SUBJECT: Requests approval of alternative method of meeting Reg
 Guide 1.63 guidelines re installation of containment
 electrical penetrations. Electrical penetration assemblies
 bolted to liner nozzles as shown on encl figures.

NIAGARA MOHAWK POWER CORPORATION

August 22, 1983
(7229)

This letter requests Nuclear Regulatory Commission approval of an alternative method of meeting the guidance provided in Regulatory Guide 1.63 regarding installation of the containment electrical penetrations for Nine Mile Point Nuclear Station-Unit 2.

FIGURE 8.3-8

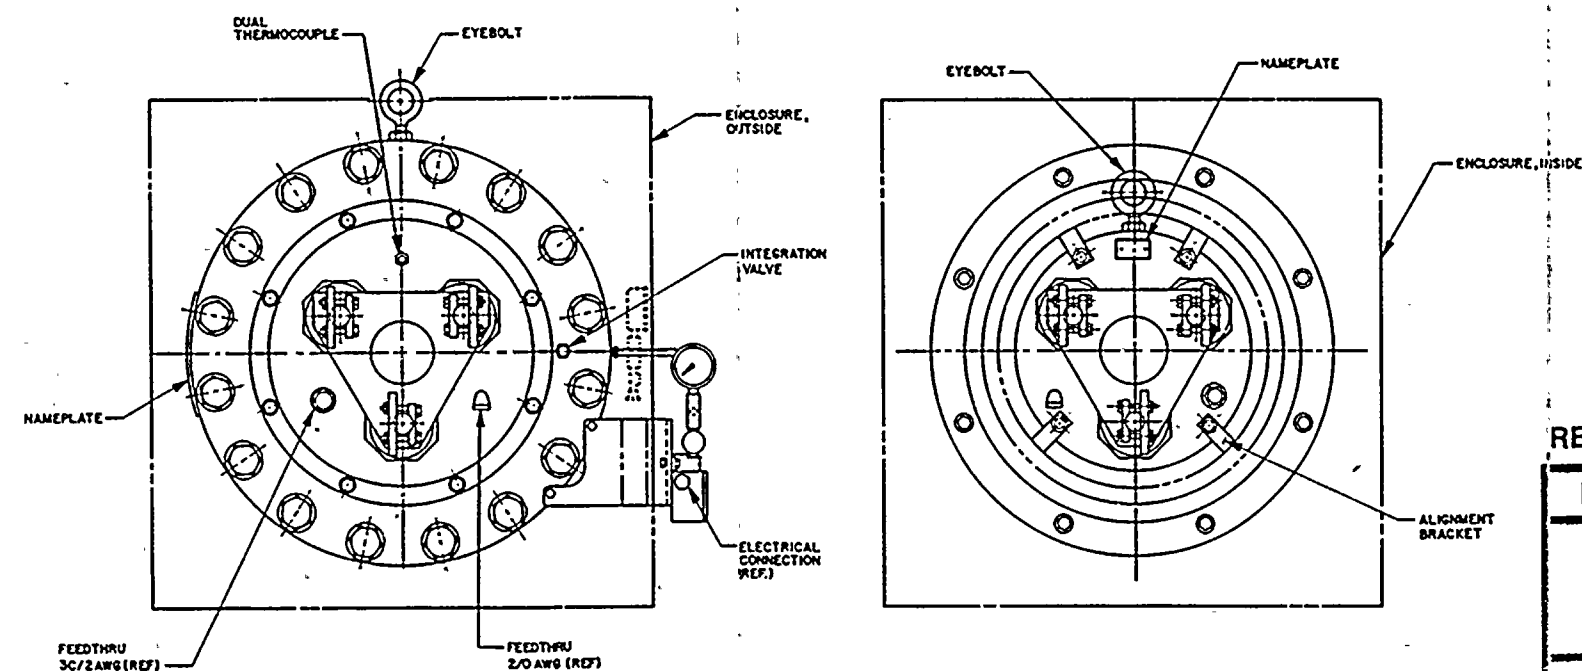
For Nine Mile Point-Unit 2, the installation of electrical penetrations would be performed under the Stone & Webster Engineering Corporation Quality Assurance Program for Category I components. The electrical penetration assemblies are bolted to the liner nozzles as shown on the attached figure. Due to the dates of order and fabrication, the liner nozzles were not required to be "N" stamped. Therefore, an ASME III program for installing these electrical penetrations is not warranted since the containment to which the penetrations will be bolted is not an N-stamped component. Installation based on the manufacturer's recommendations, in process surveillance, final visual inspection and leak rate testing performed in conformance to the Stone & Webster Engineering Corporation Quality Assurance Program will provide a high degree of assurance appropriate for the penetrations.
